AEC 11-237

Town of Orangeville File No's.: OPZ 5/10 and S 1/10  
CVC File No. T 10/001 & OZ 10/005

Re: **Response to Agency 3<sup>rd</sup> Submission Review Comments related to the  
Environmental Impact Study and Management Plan – Orangeville Highlands  
Phase 2  
East Half of Lot 3, Concession 2, Town of Orangeville, County of Dufferin**

Environmental Constraints

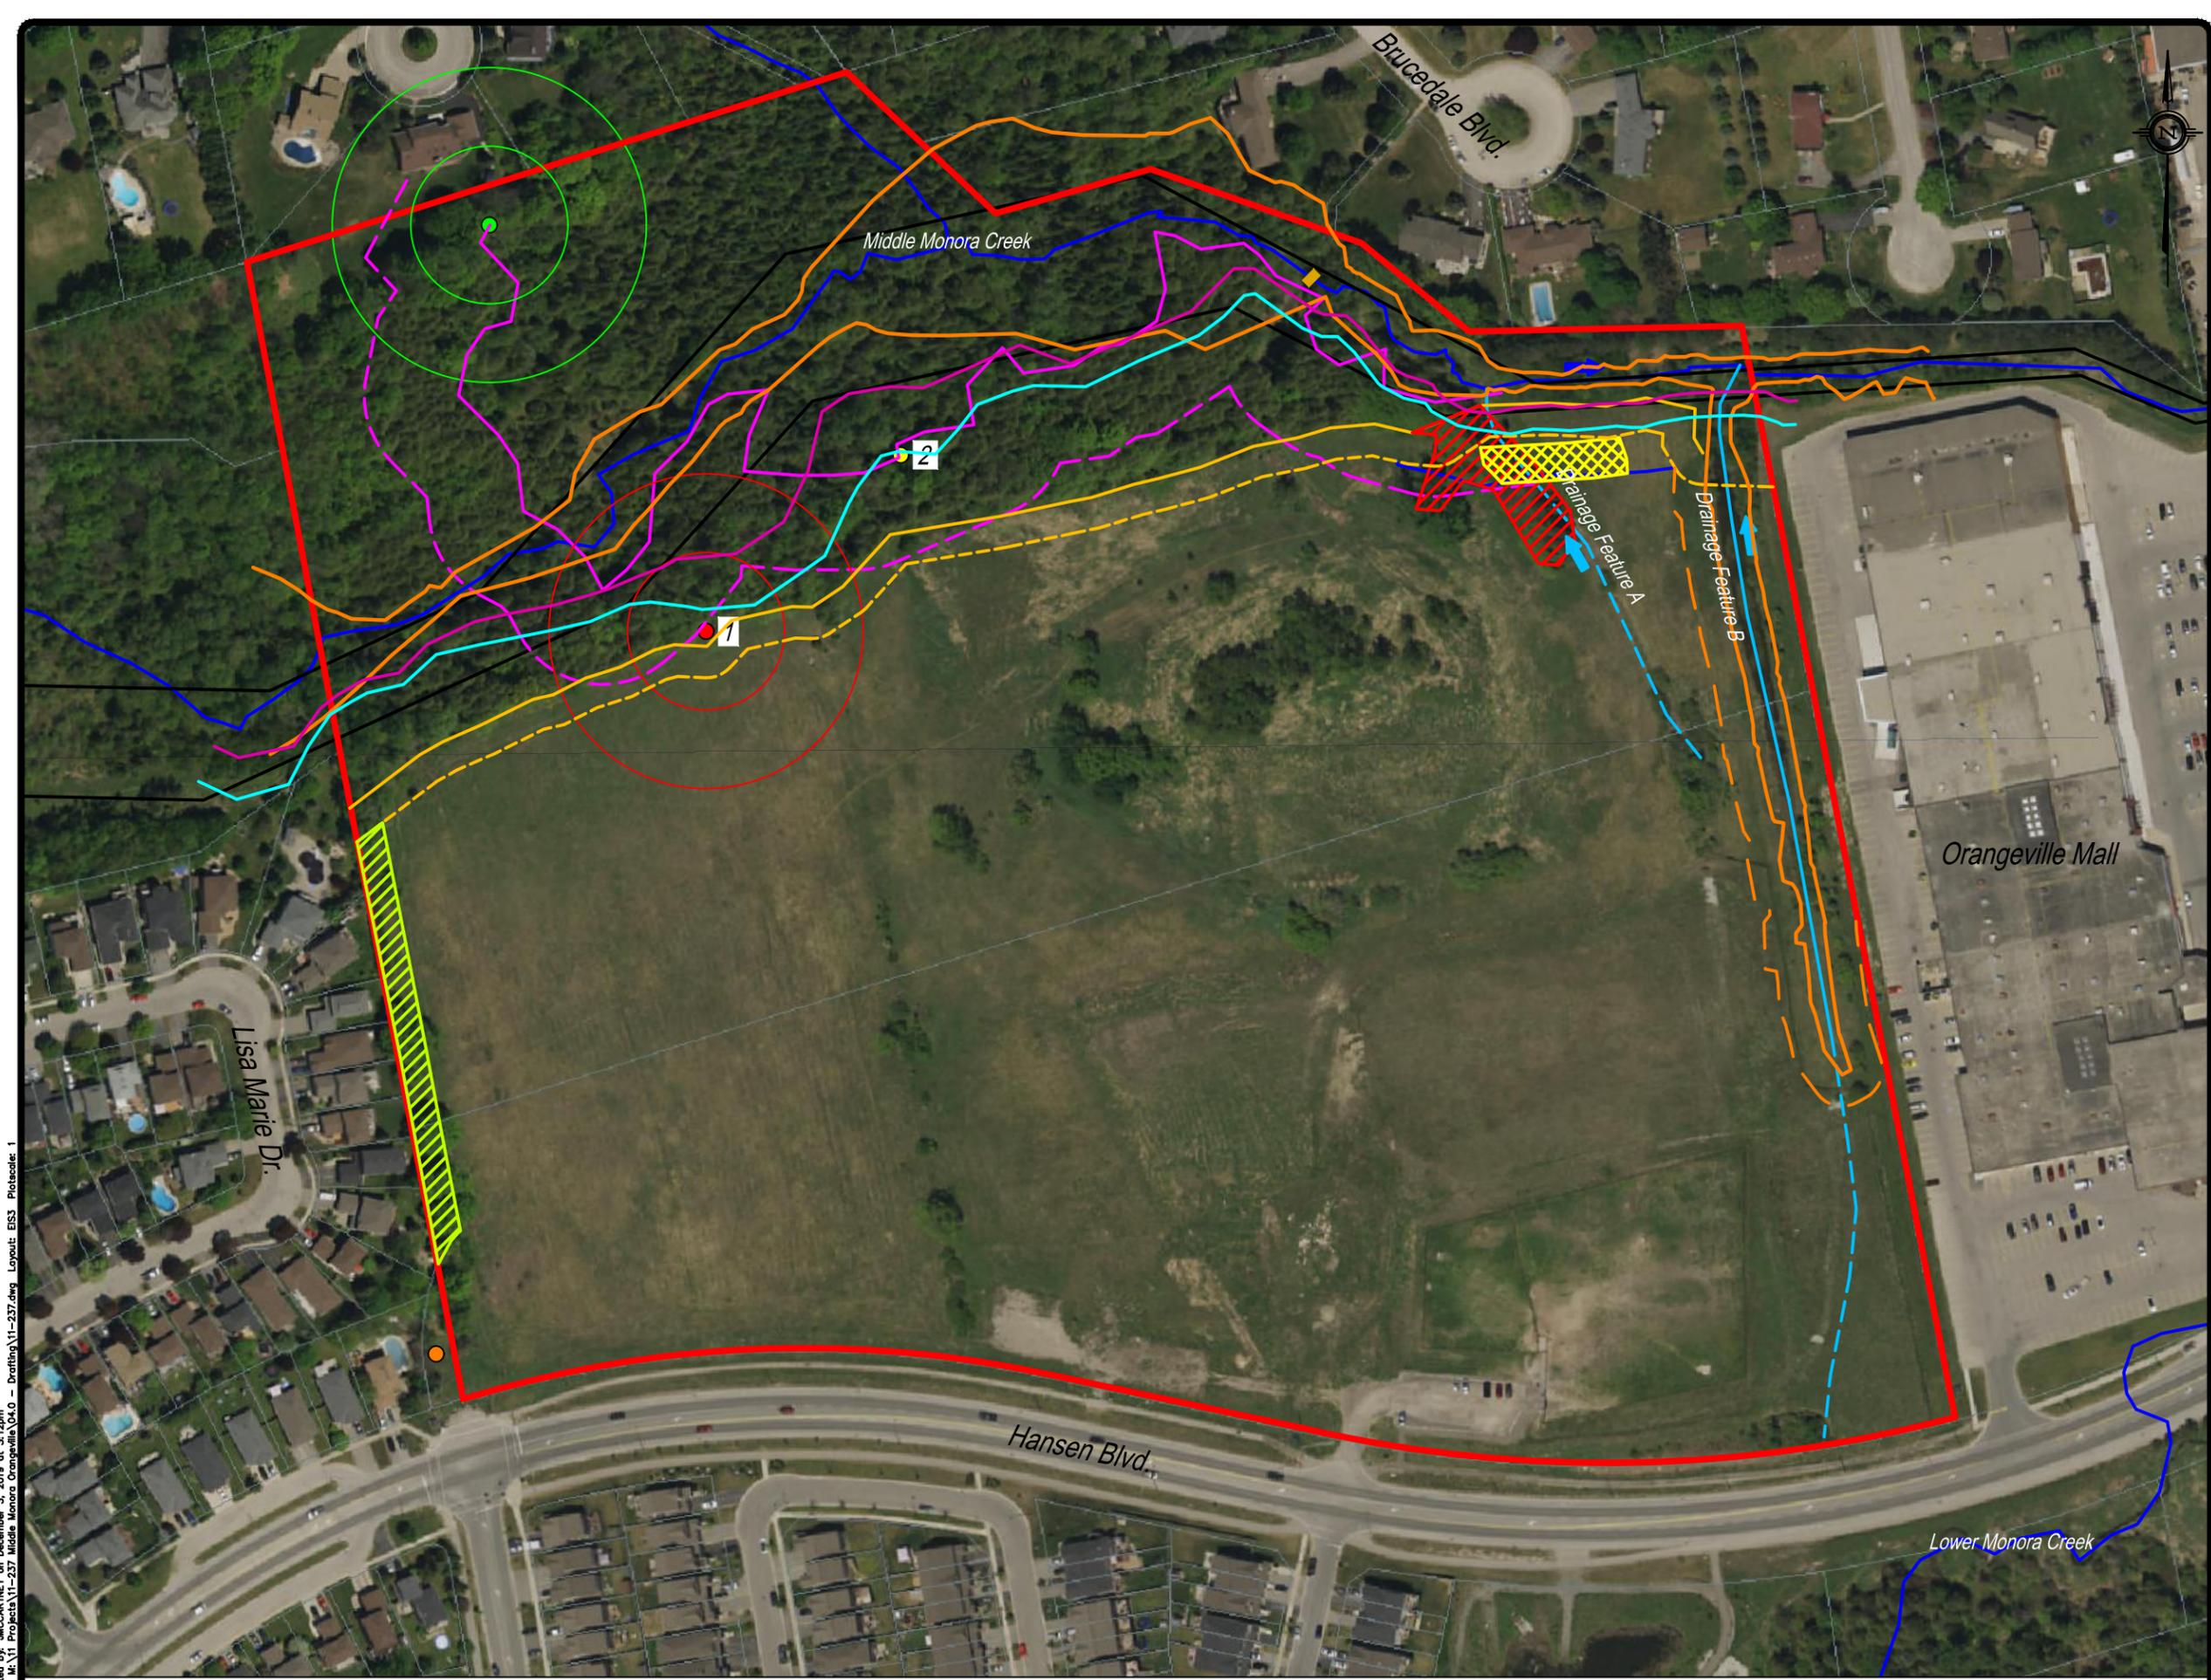
*It is unclear on the Facility Fit Plan as to where this compensation planting is to be situated. CVC comments contained herein have identified no concerns with this, provided that the Town accepts this approach. Planning Division staff have no concerns with the compensation approach occurring within the Park Block, provided that the facilities requested by the Parks and Facilities Division can be accommodated and an adequate planting buffer care can be provided along the western block boundary adjacent to the existing residential dwellings. Confirmation from the Parks and Facilities Division is required for the proposed planting/compensation approach for the Park Block 25.*

*The proposed wetland appears to be located partially within the calculated stable top of slope/meander belt. Is there a specific/functional reason why the wetland was placed in this location? Would it be possible to shift the proposed wetland further west where there is more space outside of the calculated stable top of slope/meander belt?*

*The proposed mitigation measure of planting trees and shrubs within Block 25 is acceptable. However, the location of the plantings as currently proposed does not mitigate for the loss of the portion of the significant woodland. The plantings should be re-located to the northern area of the Park Block Block 25) to be adjacent to the buffer to the significant woodland to help contribute to the form and function of the natural heritage system. Please follow up with the Town to confirm this is acceptable within their Park Block 25.*

**Azimuth Response:** The location of the proposed Compensation Planting Area is depicted on Figure 3 of the EIS (appended). Through correspondence with CVC, it has been confirmed that compensation for the woodland removed will be provided at a 1:1 ratio, therefore, the total area of proposed woodland Compensation Planting Area will be 0.11ha or greater in size. The Facility Fit Plan has been updated to indicate where the Compensation Planting Area is proposed.

**Azimuth Response:** The drawing depicting the location of the proposed wetland compensation area is conceptual. We have updated Figure 3 to move the proposed wetland away from the Stable Top of Slope/meanderbelt and have shifted it slightly to the west. The location of the proposed wetland was intended to provide supporting habitat to created amphibian breeding habitat associated with Drainage Feature B.

From an ecological perspective, the woodland that was removed (Removed Woodland, Figure 3) was:

- 0.11ha in size;
- A ‘finger’ of woodland with a maximum length of approximately 47m and width ranging from 17m – 23m;
- Likely provided edge habitat for local urban wildlife;
- Composed of primarily Eastern White Cedar; and
- Did not provide nor contribute to interior forest conditions.

The proposed woodland Compensation Planting Area (Figure 3) is:

- 0.11ha (or greater) in size;
- A ‘finger’ of woodland with a maximum length of approximately 141m and a width of 9m;
- Will provide edge habitat for local urban wildlife;
- Opportunity to increase species diversity; and
- Does not provide nor contribute to interior forest conditions.

The proposed woodland Compensation Planting Area (Figure 3) will replace the tree cover that was lost through the removal of a portion of the woodland and, once mature, will function in a manner similar to the ‘removed woodland’.

Therefore; it is our opinion that the proposed ‘finger’ woodland Compensation Planting Area will function in a similar manner to the previous woodland and has the potential to provide greater species diversity. Furthermore, its location along the western boundary of the Park Block is preferred by the Town.
